⚠ MANUAL AMENDMENT - PAGE 15

⚠ MANUAL AMENDMENT - PAGE 25

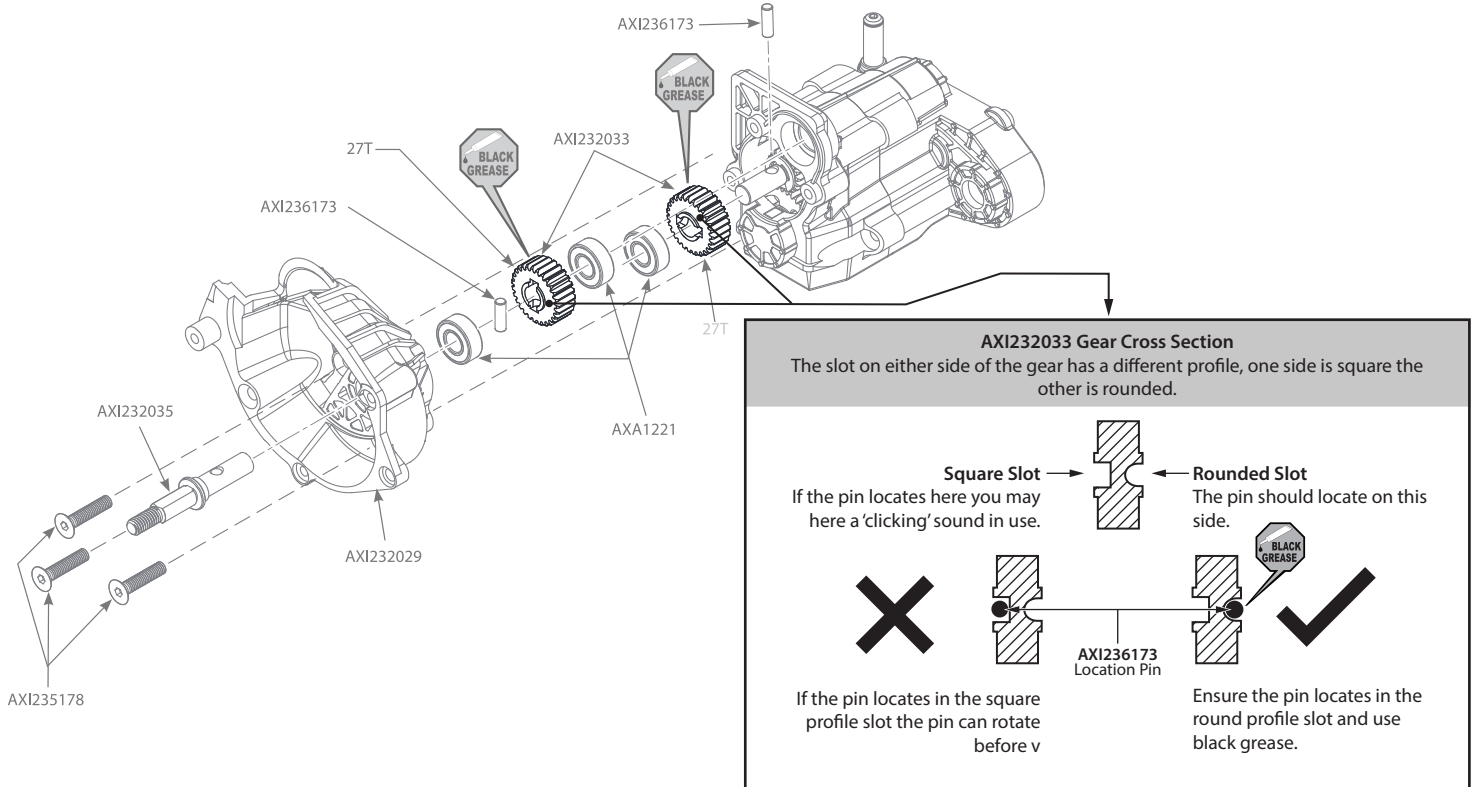
If you are noticing a 'clicking' sound whilst driving your Axial SCX10 III then it is possible that the gears (AXI232033) on page 15 of the manual have been installed incorrect. Carefully disassemble the car, remove the transmission and check the gears are orientated correctly so that the round pin locates within the rounded slot and not the square slot. Add additional black grease within the pin slot to further dampen the backlash that occurs.
